**ANP-3000(NP)
Revision 0**

**ST. LUCIE NUCLEAR UNIT 1 EPU -
INFORMATION TO SUPPORT LICENSE AMENDMENT REQUEST**

**FLORIDA POWER AND LIGHT
ST. LUCIE PLANT UNIT 1**

2.0 Issue Dispositions

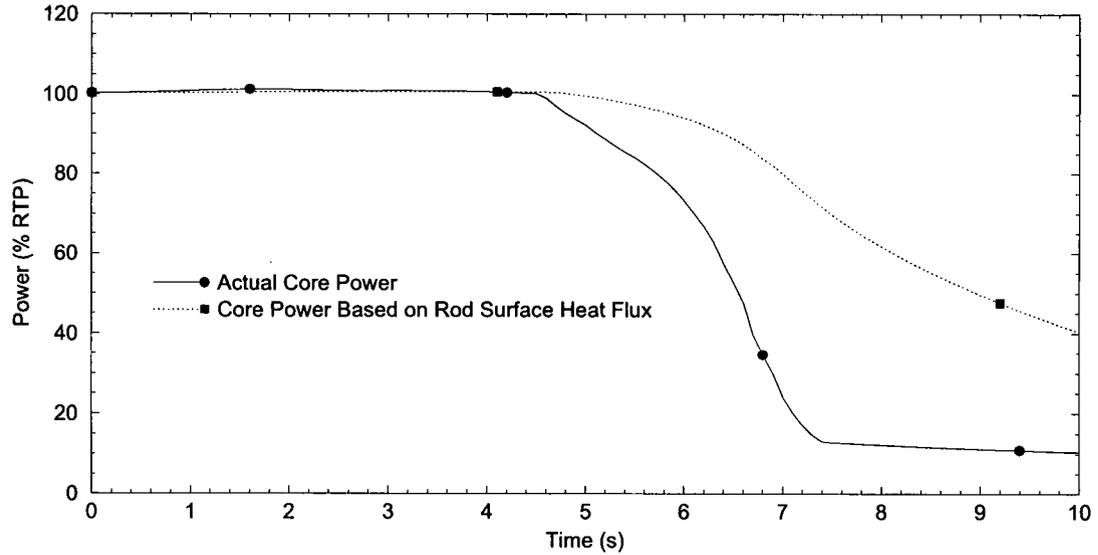
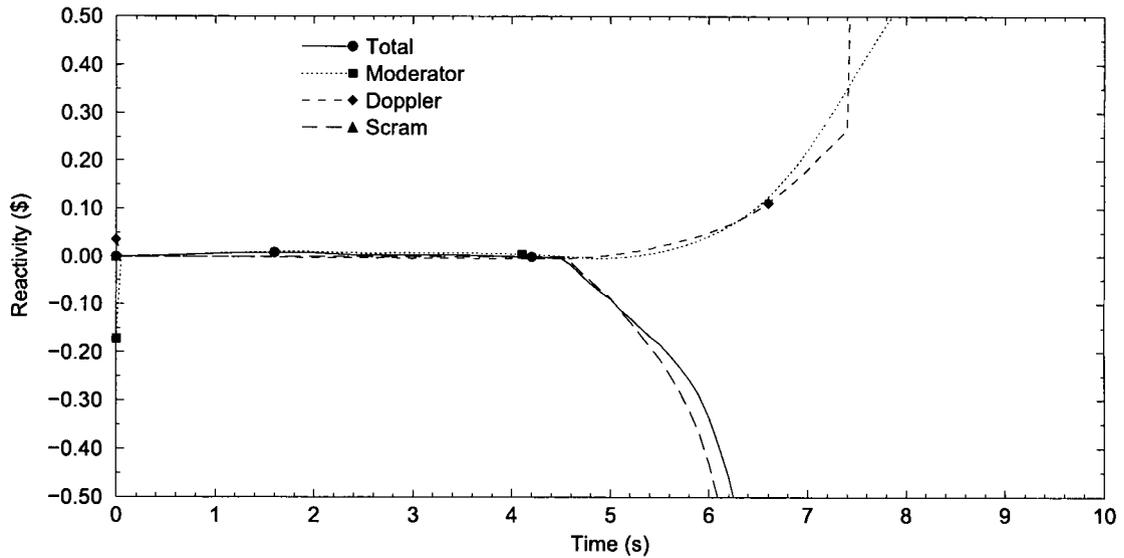
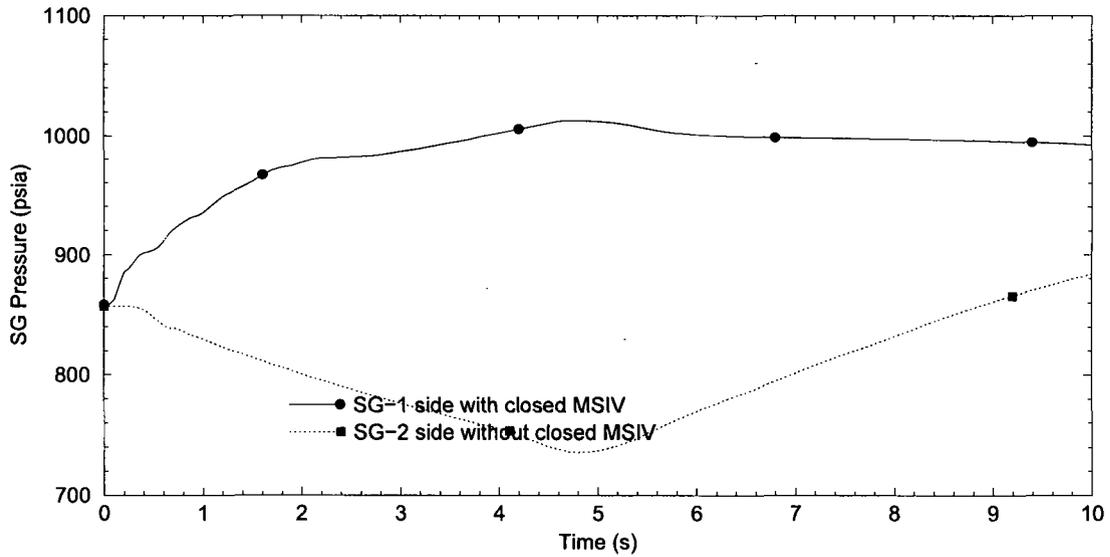
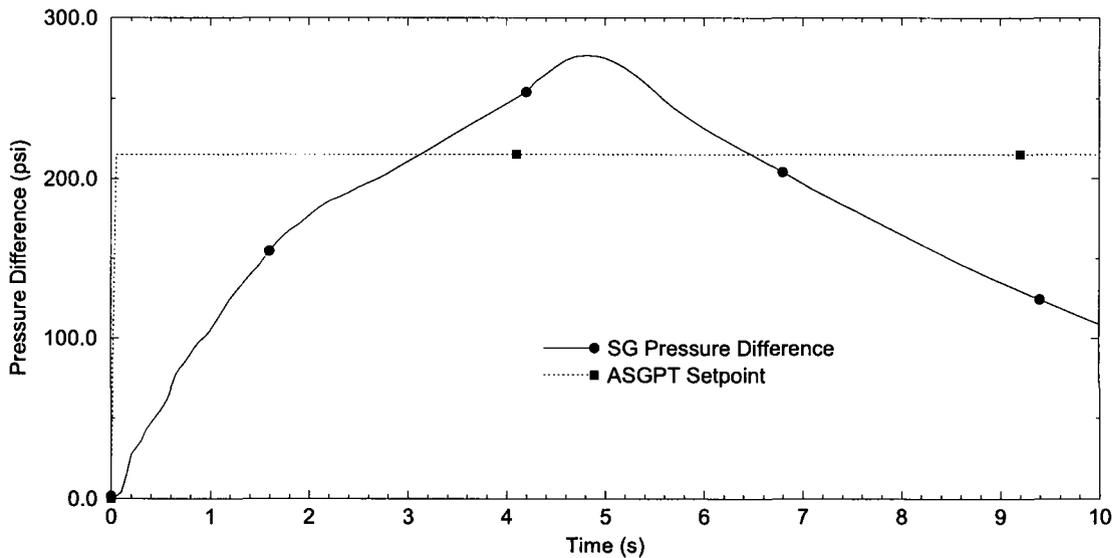
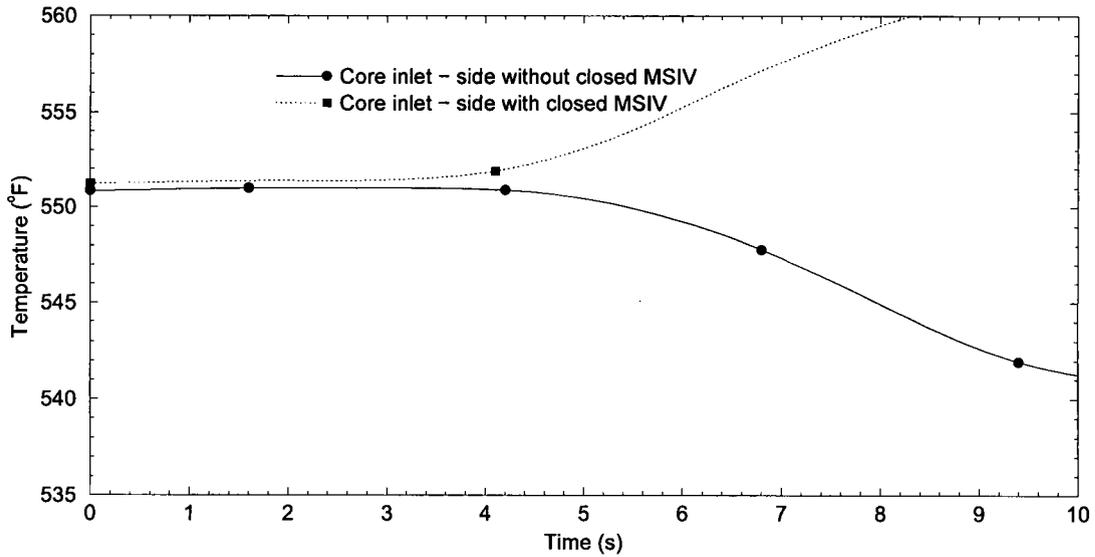
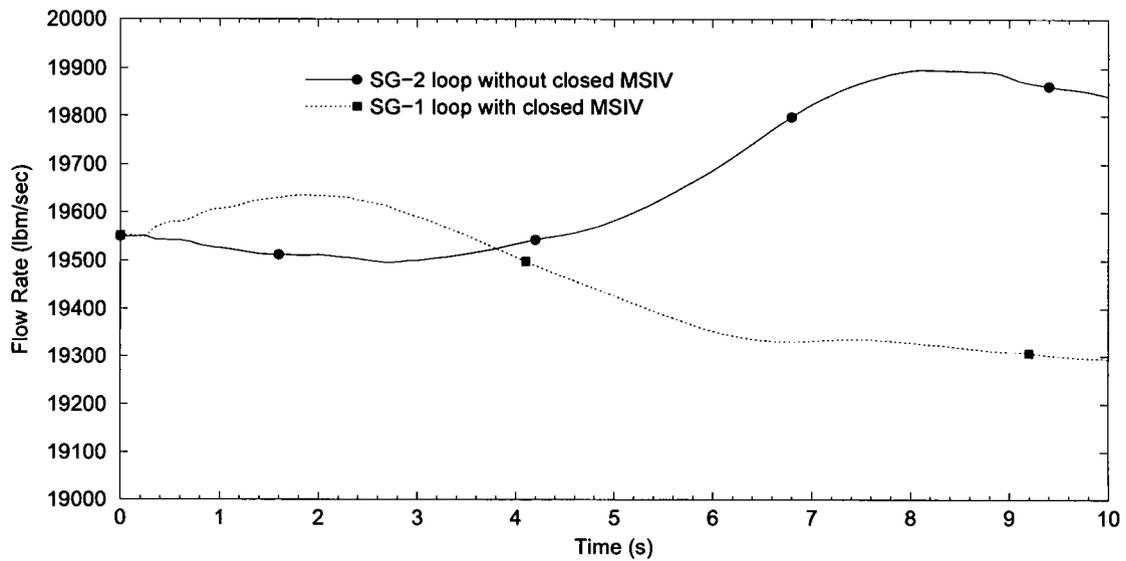
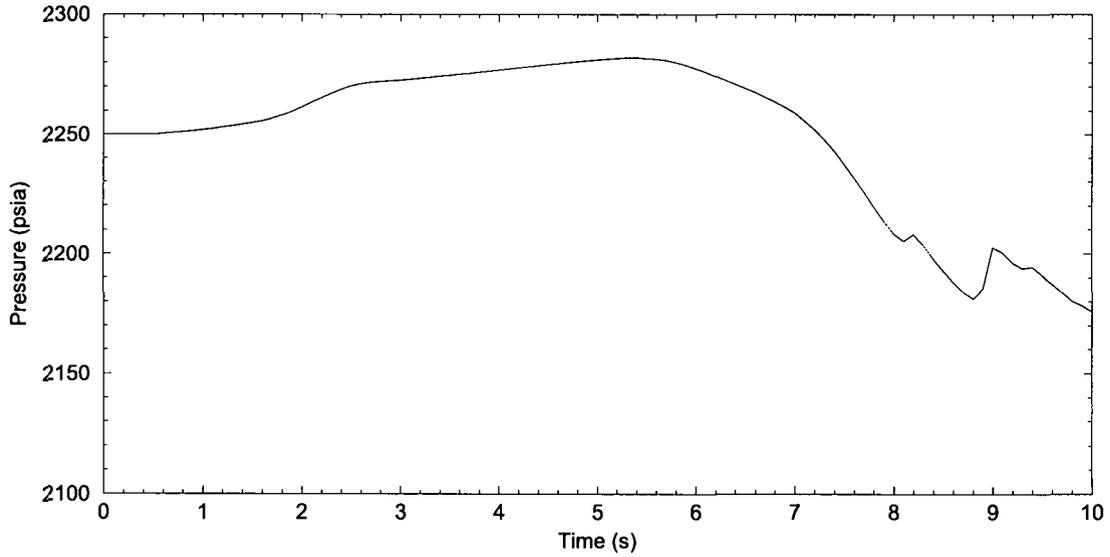
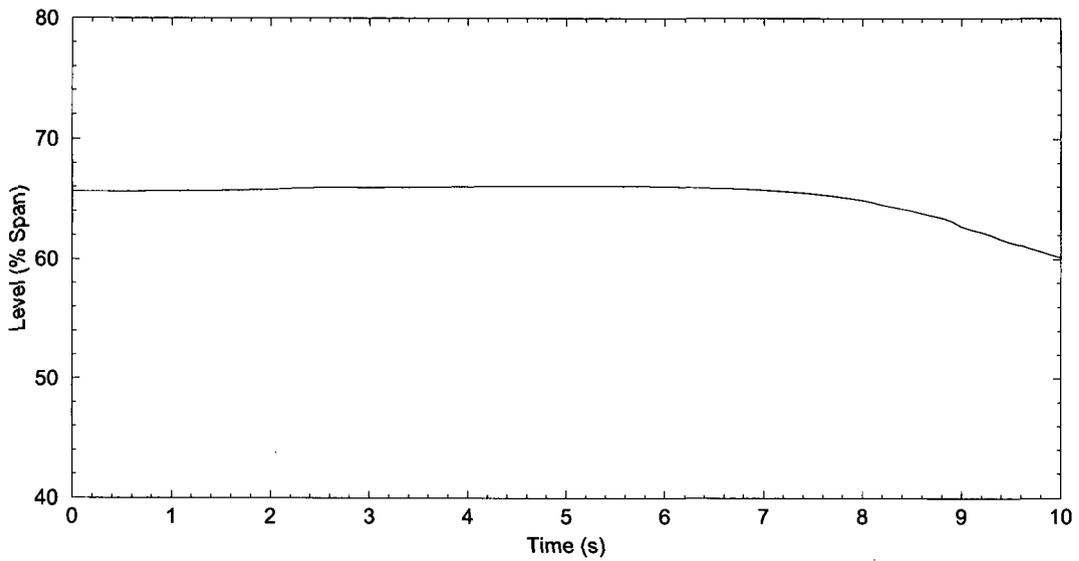
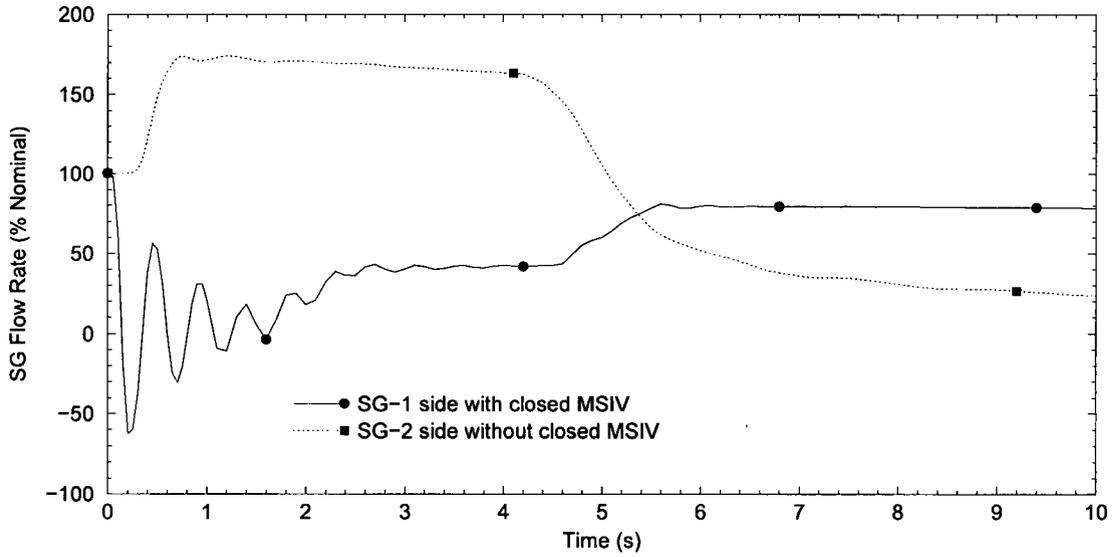
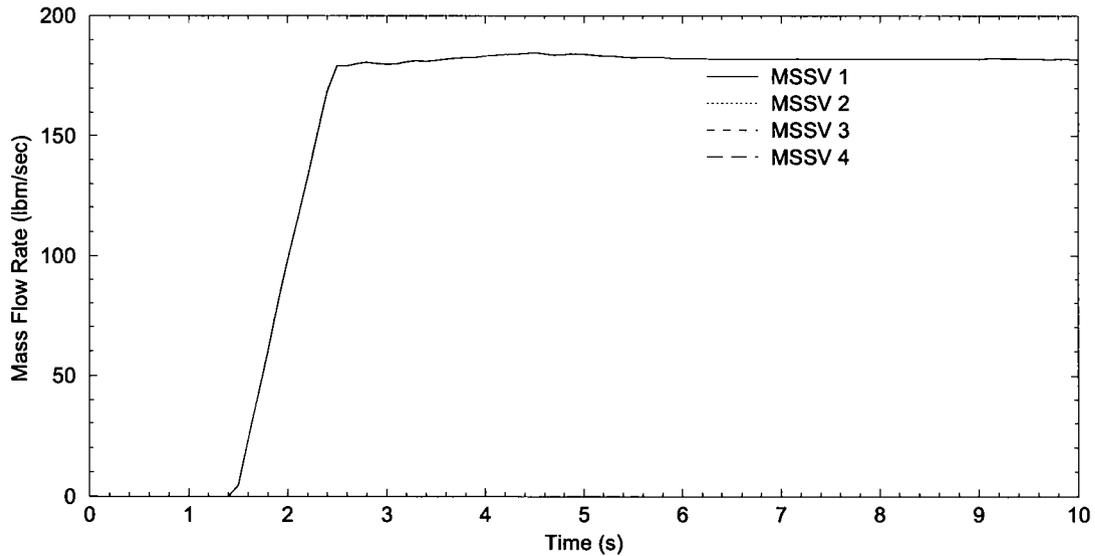
Provide an analysis of the Asymmetric Steam Generator Transient (ASGT) (i.e., Loss of Load to One Steam Generator) using a justified asymmetric core inlet temperature distribution and consequent core radial power distribution to capture the unique aspects of the ASGT.

SG-1 is defined as the SG with the closed MSIV and SG-2 is defined as the SG without the closed MSIV. Table 2.3.9-1 provides the sequence of events for both cases. Figure 2.3.9-1 to Figure 2.3.9-10 show the transient responses of key parameters for the case with an instantaneous MSIV closure time and Figure 2.3.9-11 to Figure 2.3.9-20 show the response for the case with a maximum MSIV closure time of 6.9 seconds. [

] Figure 2.3.9-3 and Figure 2.3.9-13 show the diverging SG pressures. With pressure increasing in SG-1, limited by the opening of the MSSVs, and decreasing in SG-2, the diverging SG pressures produced an asymmetric steam generator pressure trip (ASGPT) signal (Figure 2.3.9-4 and Figure 2.3.9-14). Figure 2.3.9-5 and Figure 2.3.9-15 show the asymmetric core inlet temperatures. The core inlet temperature asymmetry is less than about 3°F at the time of scram for both cases. The asymmetry increases to about 8°F by the time the clad surface heat flux drops to about 90% RTP after the scram. The case with instantaneous MSIV closure had an earlier trip time, but the asymmetry evolved more quickly. The case with a 6.9 second MSIV closure time had a later trip time, but the asymmetry evolved more slowly. [

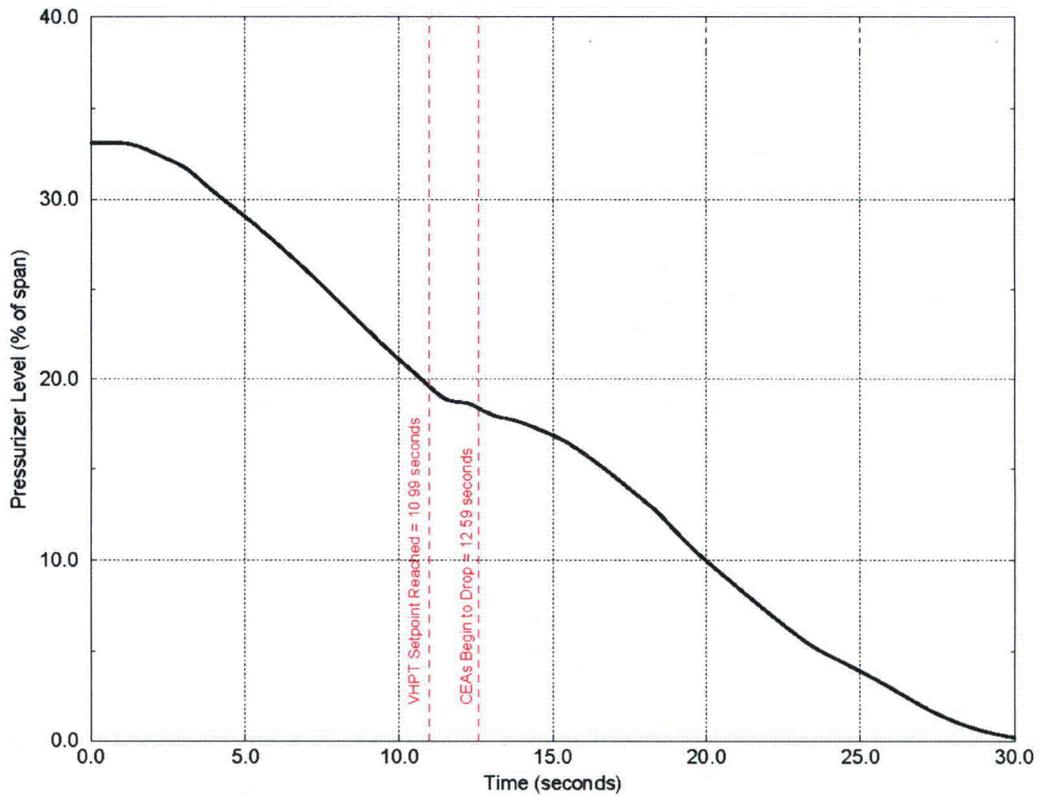
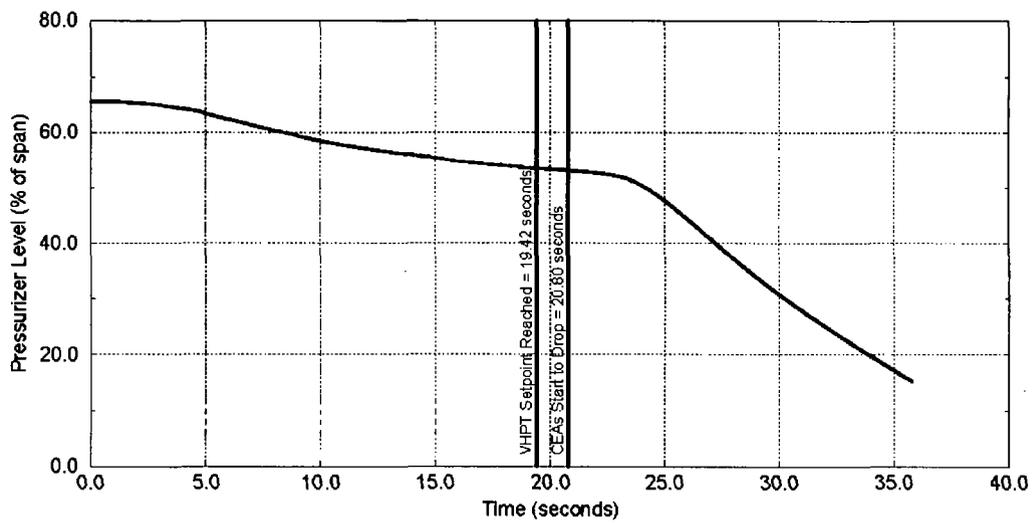
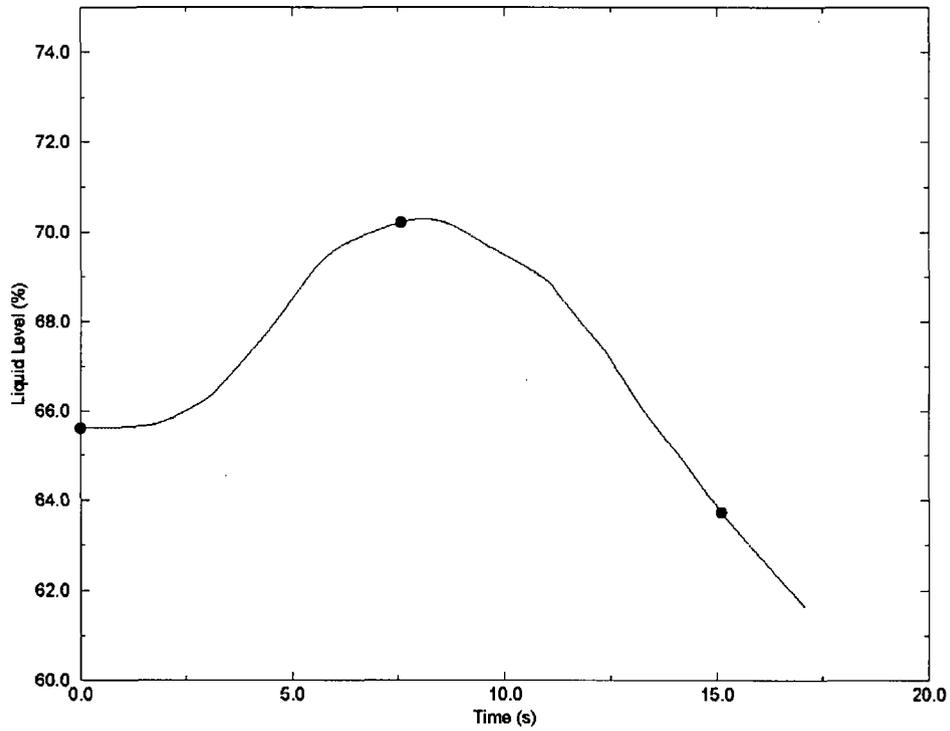
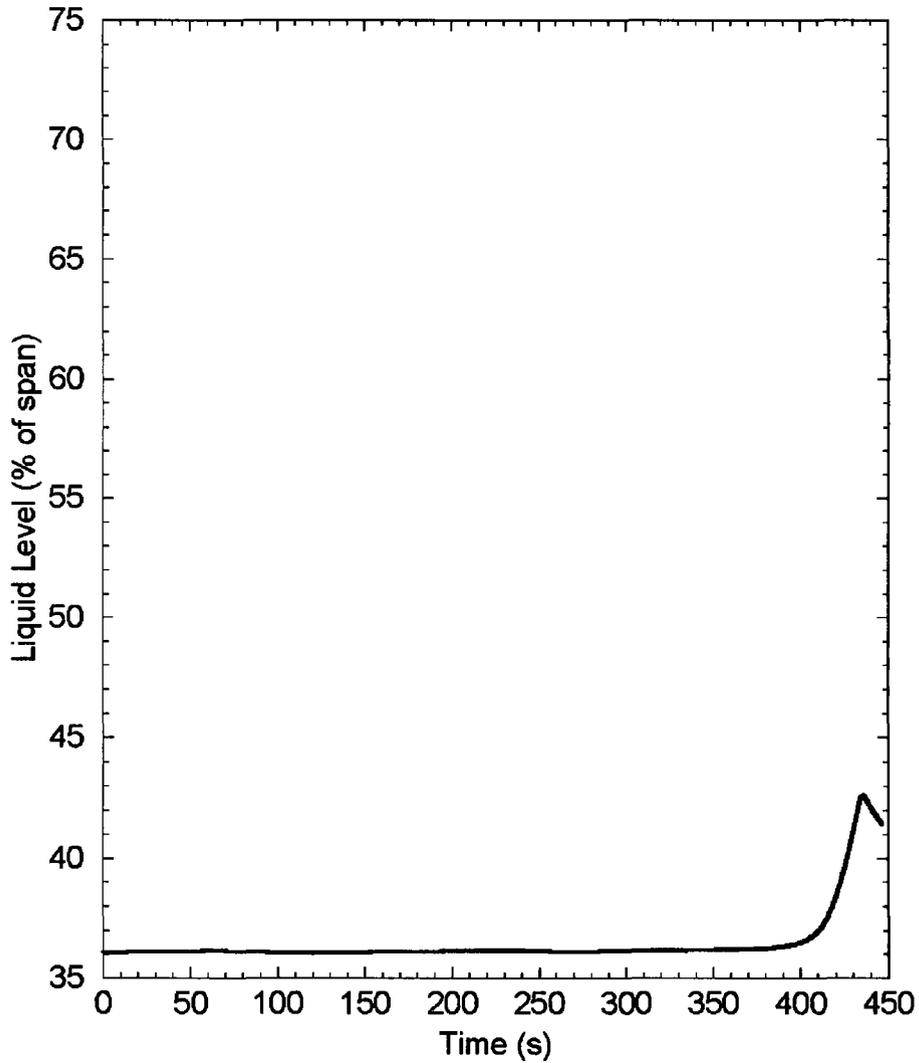
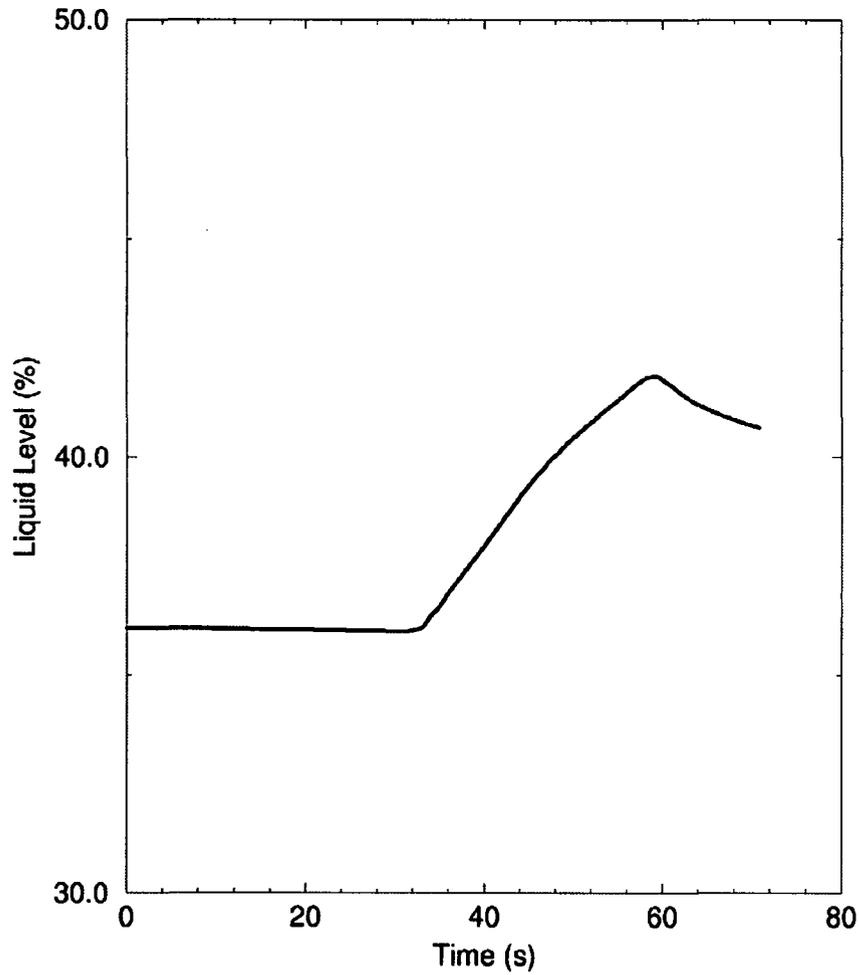
Provide pressurizer level plots for all Condition II events to demonstrate that the pressurizer does not overflow.

Table 2.3.10-1 lists the pressurizer level plots for the event analyses presented in LR Section 2.8.5.0. Pressurizer level plots are included in this response for Increase in Steam Flow, Loss of Forced Reactor Coolant Flow and Uncontrolled Control Rod Assembly Withdrawal from a Subcritical or Low-Power Startup Condition. The CVCS malfunction event that results in
